Safety Defect and Noncompliance Report Guide for Equipment  
**PART 573 Defect and Noncompliance Report<sup>4</sup>**

Generic name of the item: STEERING STOP GROUP

**DATE:** 2-2007 **BULLETIN NO:** 02-036A

**TITLE:** 200457 STEERING STOP GROUP

FIGURE 1  
STEERING STOP REPLACEMENT

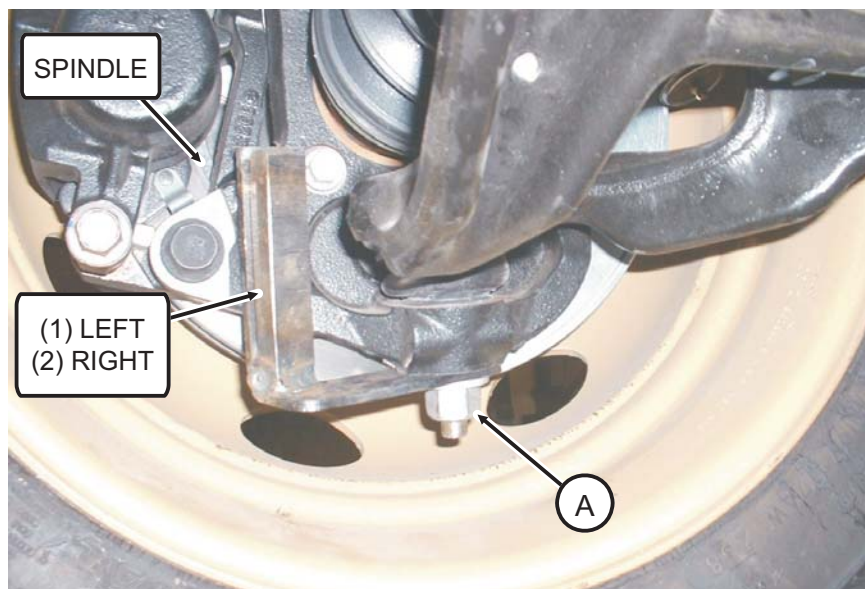
**SUMMARY:** Reports have been received that front wheels on 2001 to present Chevrolet 2500HD vehicles were found to have rubbed on the upper control arms when turning hard left or right, and particularly when bouncing on uneven ground. As a result, the anti-lock brake sensor wires have been cut. Therefore, we recommend to inspect the vehicle's front tires, wheels, upper control arms and anti-lock brake sensor wires for damage, wear, nicks, gouges, rubbing, cut or frayed wires, etc.

1. Raise the front of the vehicle high enough so both of the front wheels are off of the ground. Remove both vehicle front wheels.
2. Visually inspect the vehicle components and tires for damage, wear, nicks, gouges, rubbing, cut or frayed wires, etc. Replace any damaged or worn component as necessary.
3. Remove lower ball joint nut (A) to remove the existing steering stop (not illustrated).
4. Install the new steering stop (1 or 2) over the stud so the stop plate is towards the rear of the vehicle. Re-install lower ball joint nut (A) Push the steering stop (1 or 2) firmly against the spindle and torque nut (A) to 94 lb-ft (128 N-m).
5. Repeat Steps 3 and 4 for the other side of the vehicle.

FIGURE 3  
UPPER CONTROL ARM WITH RIB

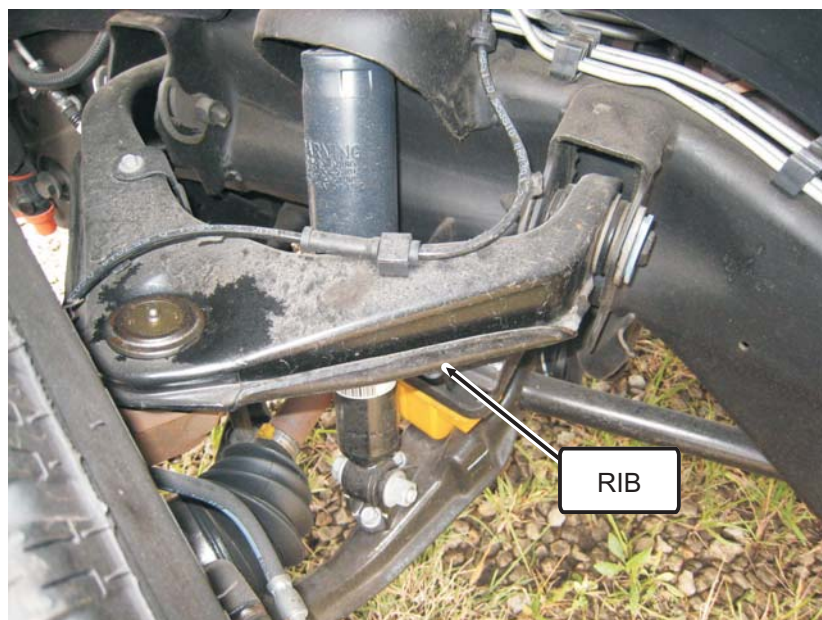
1. Determine if a control arm guard plate is or is not needed.
  - a. If the control arm on the vehicle does not have a rib, as shown in Figure 2, a guard plate is needed. Go to 3.1 Installing Control Arm Guard Plate.
  - b. If the control arm on the vehicle has a rib, as shown in Figure 3, a guard plate is not required. Go to 4.0 Anti-Lock Brake Sensor Wire Relocation.

FIGURE 6  
ANTI-LOCK BRAKE SENSOR WIRE IN NEW LOCATION

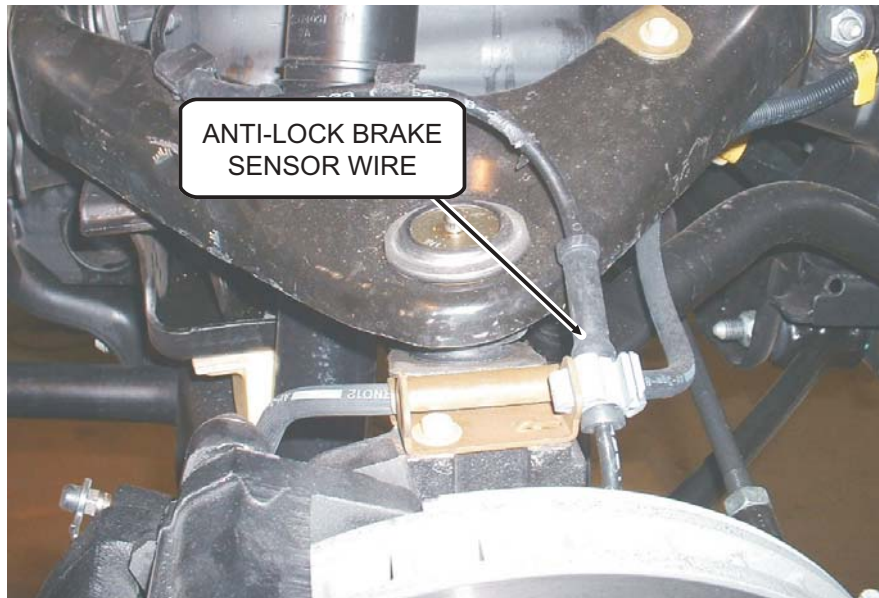
1. **Important:** Before relocating the anti-lock brake sensor wires, disconnect all electrical cables from the battery.
2. Inspect the anti-lock brake sensor wire for any damage, wear, fraying, etc. If any damage is found, replace the sensor wire.

3. Relocate the anti-lock brake sensor wire from its original mounting location as shown in Figure 5 to its new mounting location as shown in Figure 6 re-using all of the original factory mounting clips. Secure the sensor wire to the upper control arm using ty-raps as necessary.
- 4 Repeat Steps 2 and 3 for the other side of the vehicle.

FIGURE 7  
STEERING STOP MODIFICATION

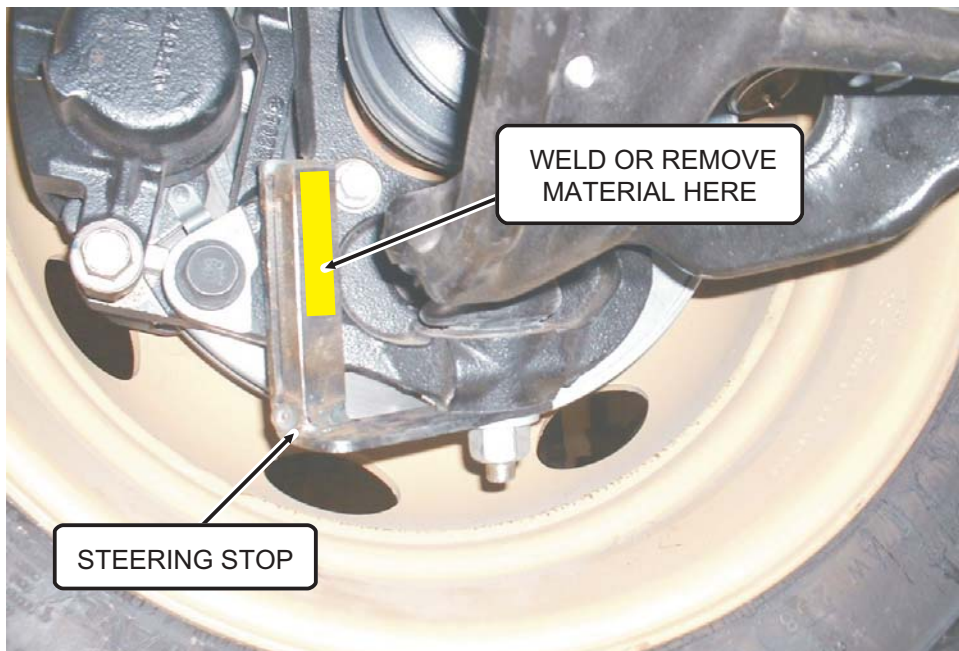
4. If there is 3/8 - 1/2 inch (9.5 - 12.7 mm) of clearance, the clearance is acceptable.
5. If there is less than 3/8 - 1/2 inch (9.5 - 12.7 mm) of clearance or any contact at all, the steering stops must be modified. Go to 6.0 Steering Stop Modification.

6. If there is more than 1/2 inch (12.7 mm) of clearance, the steering stops can be modified to help decrease the turning radius of the vehicle. Go to 6.0 Steering Stop Modification.

3. Thoroughly clean the contact area of the steering stop surface of all dirt, grease, rust, etc. where material (not supplied) will be welded to.
4. If there was less than 3/8 - 1/2 inch (9.5 - 12.7 mm) of clearance or any contact at all, weld a 1 inch wide piece of suitable material to the steering stop surface in the area shown for the thickness needed and length required. Repeat the Wheel and Tire Clearance Inspection procedure. See 5.0 Wheel and Tire Clearance Inspection.

5. If there was more than 1/2 inch (12.2 mm) of clearance, use a grinder to remove material from the steering stop surface in the area shown. Do not remove more than 1/16 inch (1.6 mm) material before rechecking the vehicle wheel clearance. Repeat the Wheel and Tire Clearance Inspection procedure. See 5.0 Wheel and Tire Clearance Inspection.
